Subject: Safety Recall B0A (interim B1A) – **Interim Notification**
Certain 2004 – 2006 model year Highlander/Highlander HV
Driver's Side Floor Carpet Cover and Retention Clips

**Certain 2004 - 2006 Model Year Highlander/Highlander HV
Floor Carpet Cover and Retention Clip
Safety Recall Notice (*Interim Notice*)**

Safety Recall B0A (INTERIM B1A) – INTERIM Carpet Floor Cover and Retention Clip Inspection 2004 through Certain Early 2006 MODEL YEAR Highlander/Highlander HV

**Safety Recall 90L (INTERIM 91L) Phase 11 RAV4
Floor Mat Inspection, Application and Semi-Permanent Installation Instructions**

Part Number	Part Description	Quantity
90467-06020-C0	Retention Clip	(As Needed)

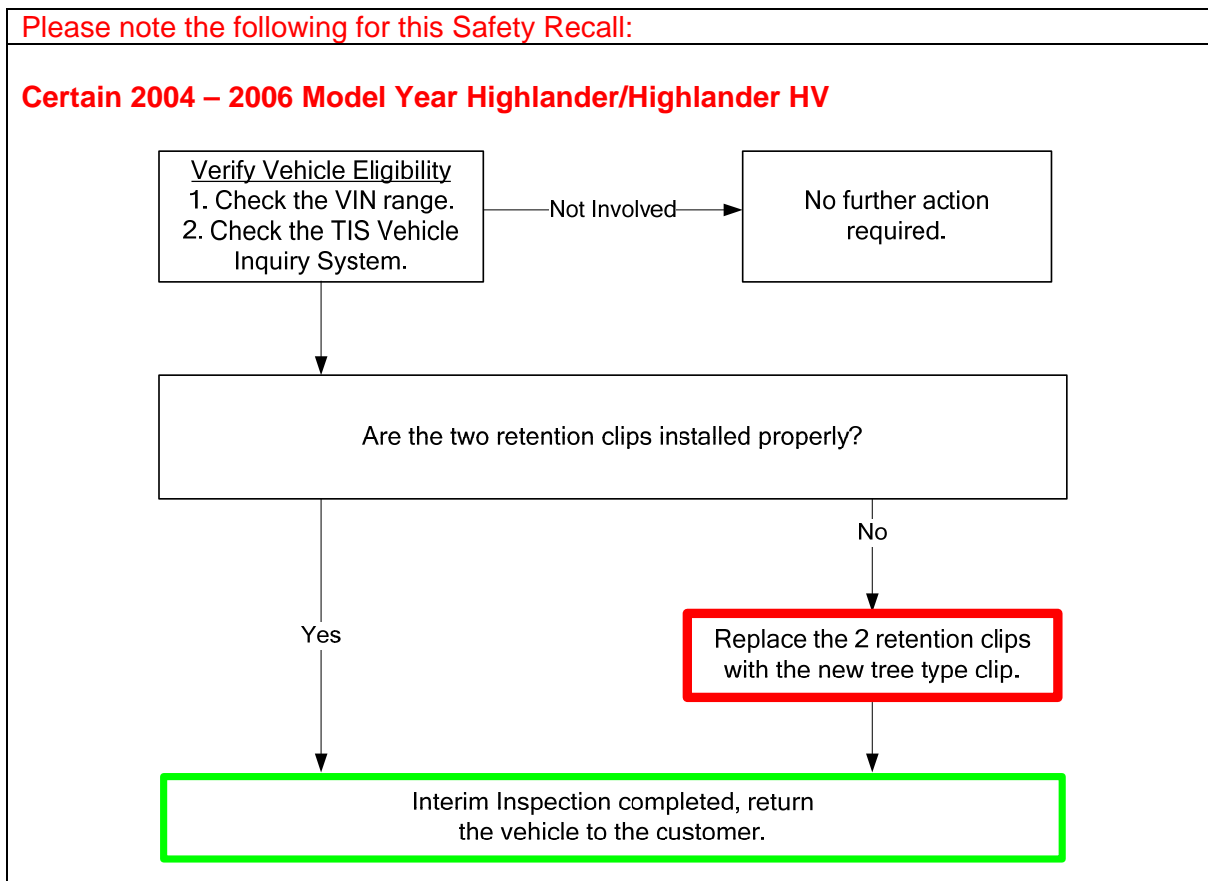
A new specification retention clip (one piece tree type) can be ordered through your dealerships facing PDC. This retention clip will also be provided with the remedy Floor Carpet Cover when it becomes available. Therefore, this clip will be placed on Manual Allocation Control to assure an adequate interim supply for all dealerships.

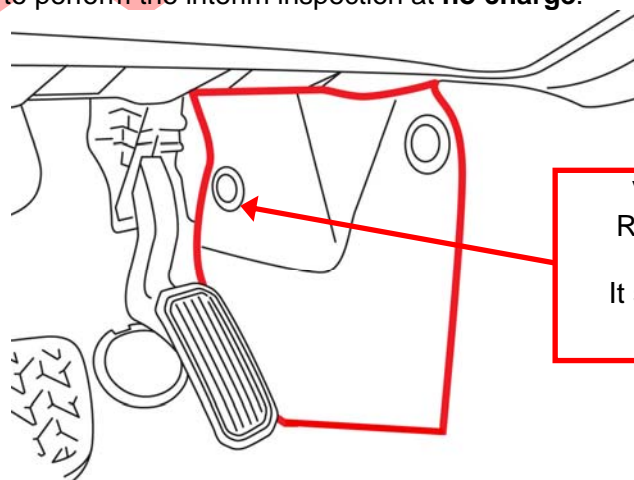
In certain 2004 through 2006 model year Highlander/Highlander HV vehicles, if the forward retention clip used to secure the driver's side Floor Carpet Cover, which is located in front of the center console, is not installed properly, the cover may lean toward the accelerator pedal and interfere with the accelerator pedal arm. If this occurs, the accelerator pedal may temporarily become stuck in a partially depressed position rather than return to the idle position. An accelerator pedal temporarily stuck in a partially depressed position may increase the risk of a crash.

Verify that the Forward Retention Clip is properly installed. It should not be missing or loose.

1. Necessary Materials

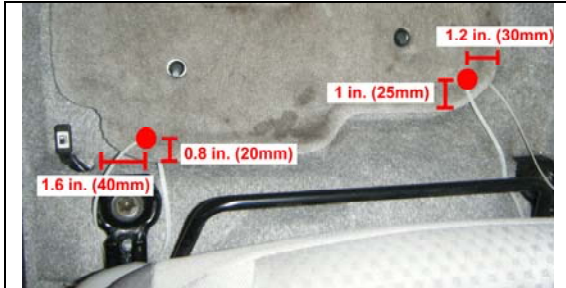
- Self-locking nylon tie-wraps (Rated at 50 pounds minimum, 0.19 inches wide and 17 inches long)
- Easy Peel Labels (Use Avery® 5260™)
- Thin Flat-Head Screwdriver
- Fine-Pointed Punch
- Ruler
- Diagonal Cutting Pliers
